Site visit from 17.08.2011 09:30-12:30 o'clock

Wednesday, August 17th was my first site visit and thus my initial focus was on the overall process and scope of the participants in the redevelopment of 644 Riverside Drive. Based on my initial visit please find below my findings:

Site visit from 05.10.2011 01:00-02:45 o'clock

Photo 1 of 2 - Inadequacies - Plans Front Entrance

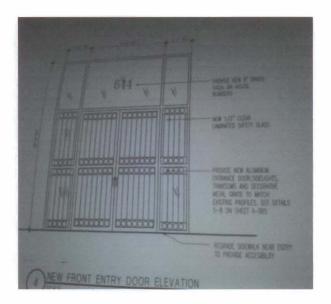
According to the design documents the front entrance doors were to encompass decorative metal grates to mimic the original doors. This application has yet to be installed or was eliminated during value engineering.
